Arden Structure Plan Advisory Committee Draft Amendment C407 and draft Arden Structure Plan

Expert Odour Report – Arden Asphalt Plant

7 February 2022

Figure 4. Morning and Afternoon Wind Roses for Essendon Airport

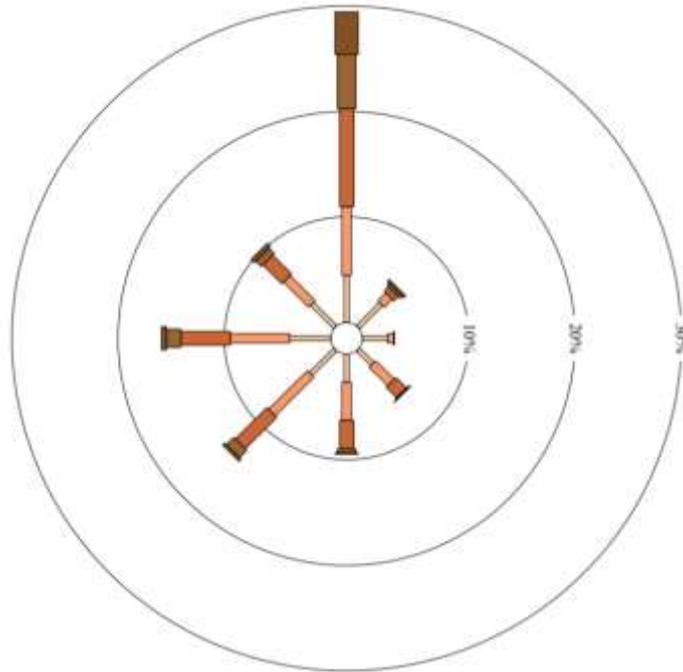
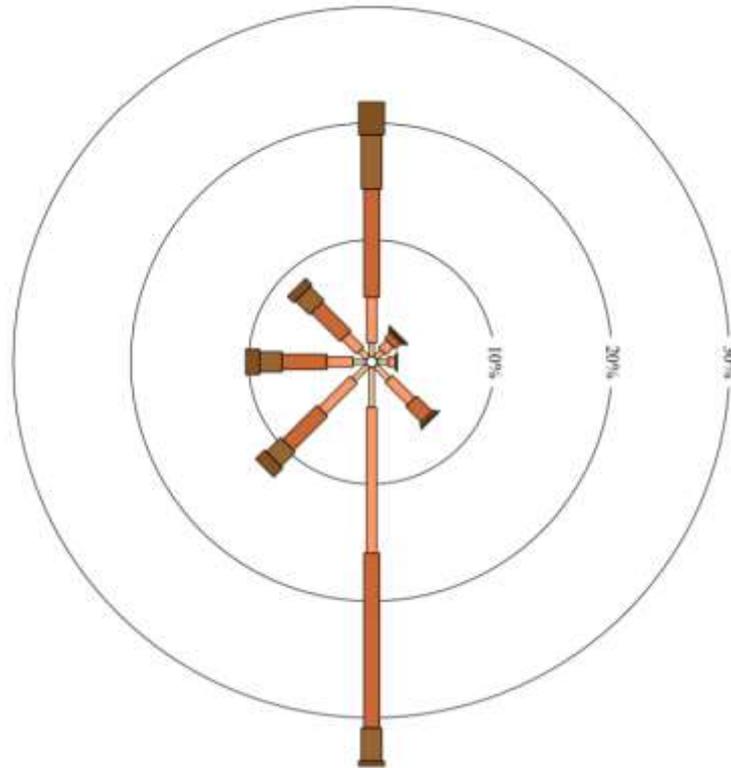
Both the CEE and GHD odour surveys show a concentration of odour impact on Arden Street, and the streets north and immediately east of the site. The distribution of odour does not correspond strongly with the north/south wind pattern apparent in the annual wind rose for Footscray (Figure 5-4 of GHD report) or the similar north/south wind pattern in the 9 am and 3 pm wind roses for Essendon Airport (see Figure 4). The reasons are:

Noting the complexity of the wind directions at ground level, as discussed above, the wind roses in Figure 4 indicate that the buffer distance should extend equally to the north, east and south of the stack. The site (and Melbourne in general) experiences few winds from the east. However, the odour survey results show the odour extended well down Arden Street to the west.

Therefore, it is considered that circular buffer zones are reasonable. If necessary for planning purposes, it also would be reasonable to vary the lines delineating the buffer zones by a small distance to adjust the boundary to match property or planning boundaries.

Figure 5. Comparison of Results of CEE and GHD Odour Surveys

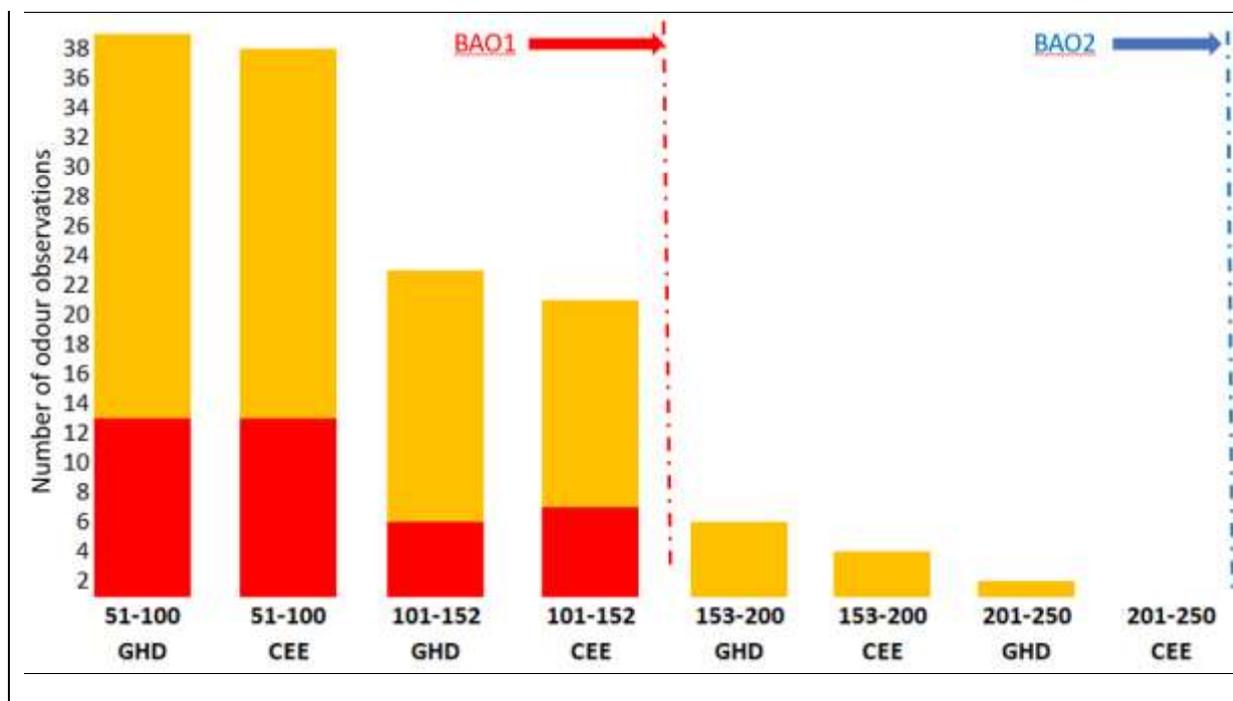
The proposed BAO1 extends for 152 m from the stack on the asphalt site. The odour survey results summarised in Figure 5 provide strong support for the size of the BAO1 and the exclusion of odour-sensitive land uses from within 152 m of the asphalt plant activity boundary.

The proposed BAO2 extends for 153 m to 377 m from the stack on the asphalt site. The odour survey results show only a small number of observations of subtle odour between 153 m and 250 m from the activity boundary (plus the single additional observation at 377 m from the stack).

Even so, in my opinion, there is not a strong justification to extend BAO2 beyond a distance of 250 m from the stack. For that reason, I have shown the extent of BAO2 as 250 m in Figure 5.

3. The proposed BAO2 extends for 153 m to 377 m from the stack on the asphalt site. The odour survey results show multiple observations of subtle odour between 153 m and 250 m from the activity boundary but only one beyond 250 m which is the single observation at 377 m from the stack. Based on the results of the two odour surveys, I recommend that the extent of BAO2 be limited to 250 m from the stack.

Figure 6. Comparison of Results of CEE and GHD Odour Surveys

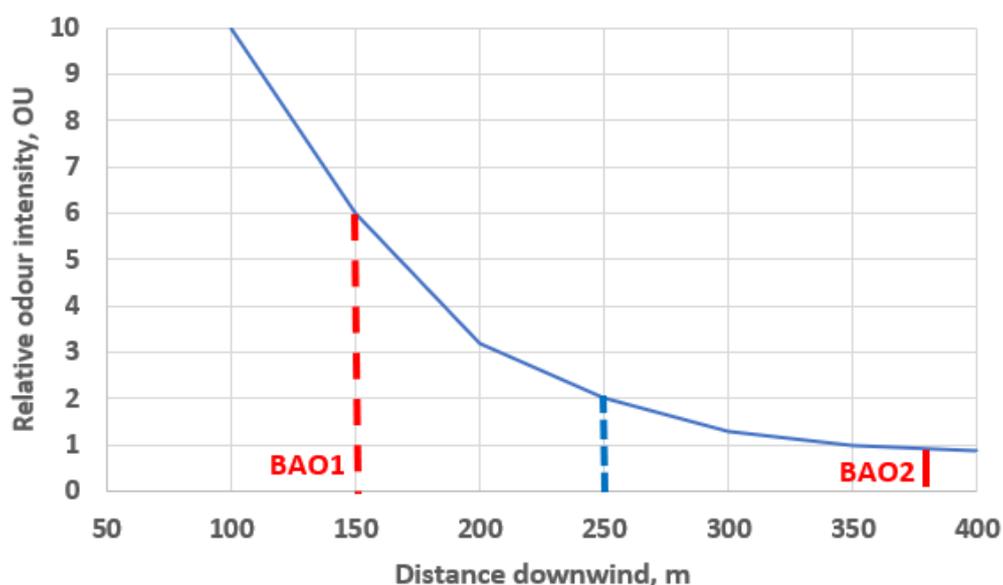
The blue line in Figure 6 illustrates the relative odour level with distance. Note that these are not actual odour levels, as no measurements have been made of the odour emission rates. The purpose of the figure is to show the relative odour levels at the edge of the zones defined by BAO1 and BAO2. If the edge of BAO1 corresponds to 6 OU, the edge of BAO2 corresponds to 1 OU. This is a large margin of safety

Based on the site inspection and the results of the odour surveys, emissions from the site are similar from day to day. Larger emissions are likely when the equipment is open for major maintenance but, overall, the peak rate of odour emissions are estimated to be 2 to 3 times the rate on days with average emissions.
